MN/MR
15313
22 June 2015

**SECTION 75W MODIFICATION APPLICATION TO MP 09_0007
STAGE 1 MOORE THEOLOGICAL COLLEGE RESOURCE AND RESEARCH BUILDING**

Figure 5 – Shadow comparison of approved and proposed building envelope at 3pm on the winter solstice

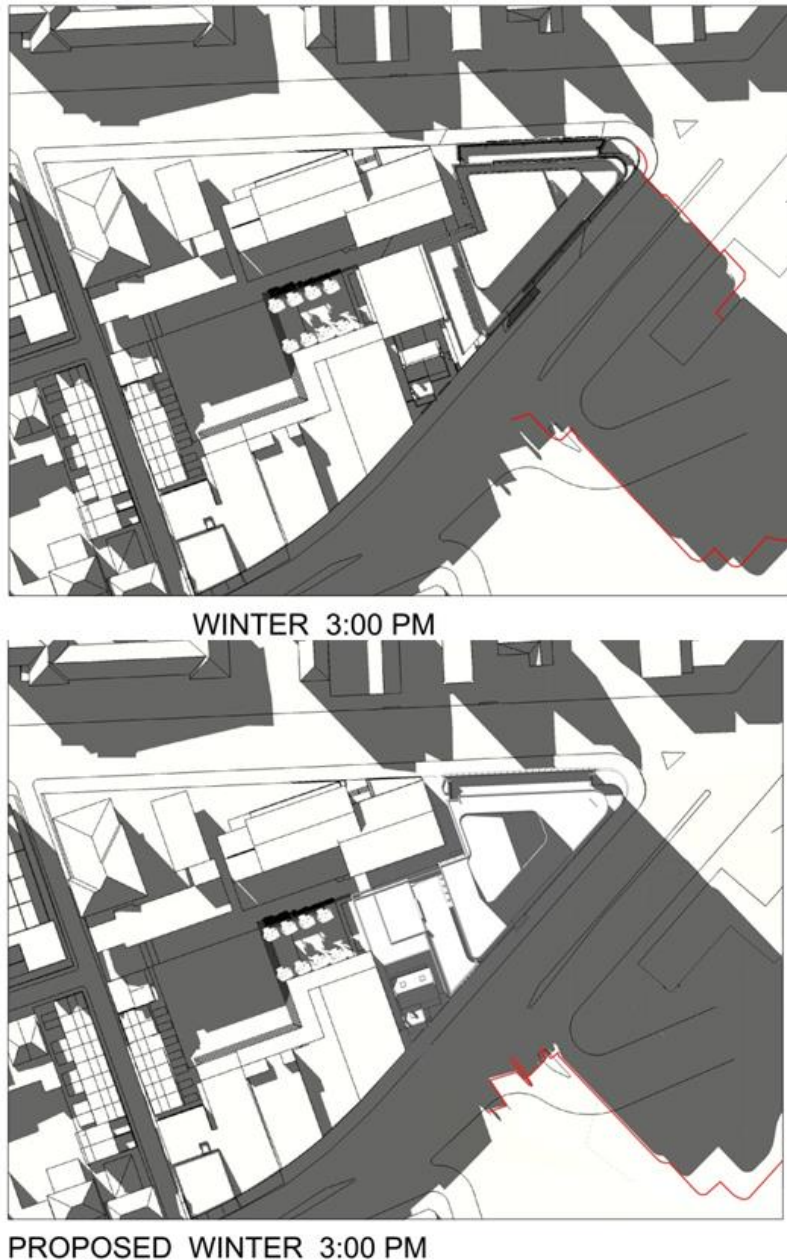
The modification will reduce the height and footprint of the building plant, reducing the extent of the shadow cast by the building. **Figure 5** below demonstrates the reduced extent of the shadow cast by the modified building envelope compared with the approved envelope at 3pm the winter solstice.

As shown above, the extent of the shadow cast by the proposed modification is lesser than that of the approved building.
